WRITTEN REPRESENTATION FOR SPR EA1N and EA2 PROJECTS (DEADLINE 1) ONSHORE ECOLOGY

Interested Party: SASES PINS Refs: 20024106 & 20024110

Date: 30 October 2020

Annex 4. Proximity of Billeaford Hall to the cable route (Lesser Horseshoe Bat sighted in this area)

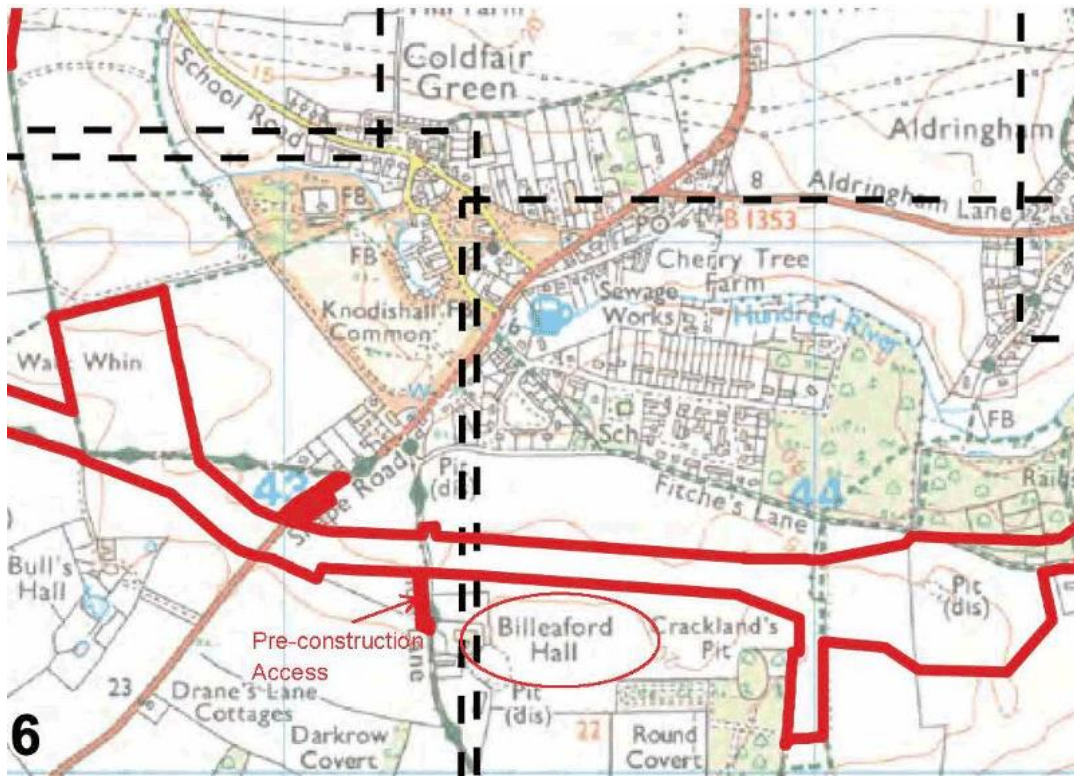
29. SPR have identified the presence of a **Lesser Horseshoe Bat** in Transect 3, in the vicinity of Billeaford Hall (Sheet 22.8c of 6.2.22.8/APP-281), very close to the cable route. (*Annex 4 – map*). This is a very rare species and there has been only one other sighting in Suffolk in the last 100 years. (*Information from Suffolk Wildlife Trust*). SPR have been asked to investigate this sighting in more detail, but have declined to do so. There should be a proper investigation before a decision on this Application is made.

Annex 6. Seasonally flooded pit on substation site

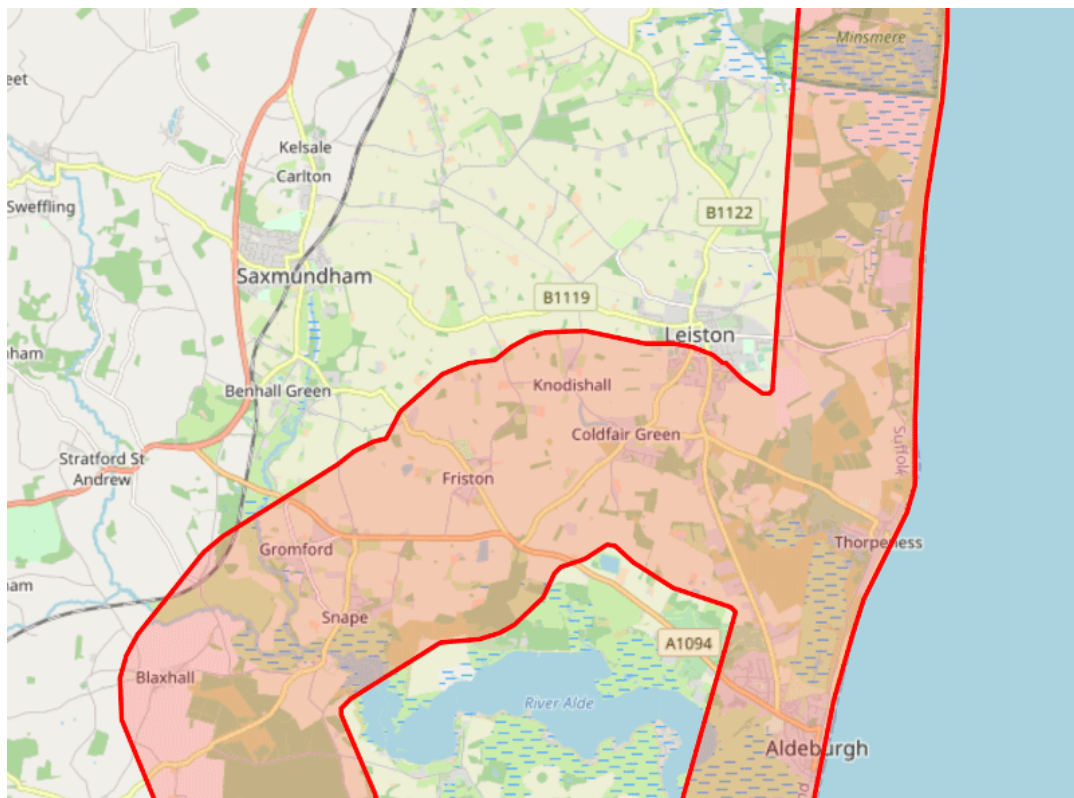
40. SPR have omitted to record that a pit on the substation site, where EA1N is proposed to be built, is seasonally flooded and this therefore adds a further waterbody which has not been surveyed. A survey should be carried out in the winter 2020/21. (*Annex 6 – flooded pit on substation site*)
